To: T10 Technical Committee  
 From: Rob Elliott, HP (elliott@hp.com)  
 Date: 26 April 2007  
 Subject: 07-177r1 SAS-2 Port layer wide port ordering

### **Suggested changes to SAS-2**

**Figure 1 — Wide connection examples**

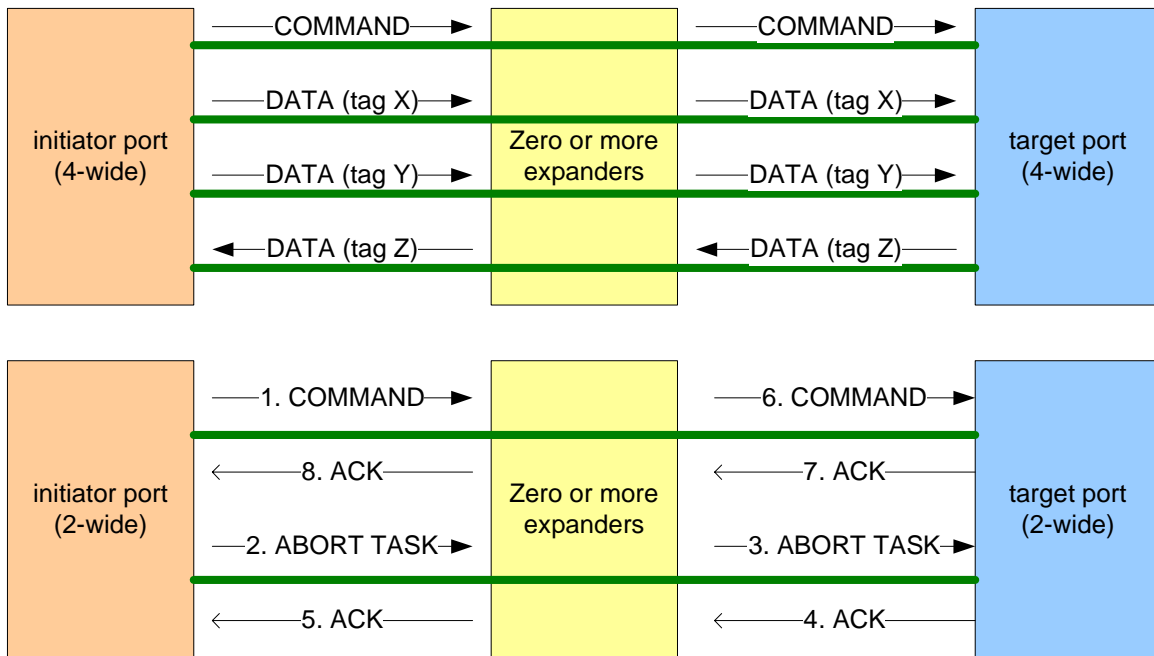
A wide port can have multiple connections open to another wide port at the same time. A port cannot prevent this from happening; for example, always rejecting the second incoming connection request could lead to a livelock if both ports implement that algorithm and their connection requests cross on different logical links. Although order is maintained within each connection, there is no ordering guarantee across multiple connections. If the wide port sends a frame on logical link 0 and then sends a frame on logical link 1, they might arrive at the destination in the original order, simultaneously, or in reverse order.

Provided it does not cause ordering problems, the wide port can and should send frames simultaneously on multiple logical links to take advantage of the extra bandwidth. This is particularly important for DATA frames, which are already non-interlocked within connections and should be allowed to be transferred concurrently with other frame types on other connections. It is not as critical for COMMAND, TASK, XFER\_RDY, and RESPONSE frames, which are already interlocked within each connection.
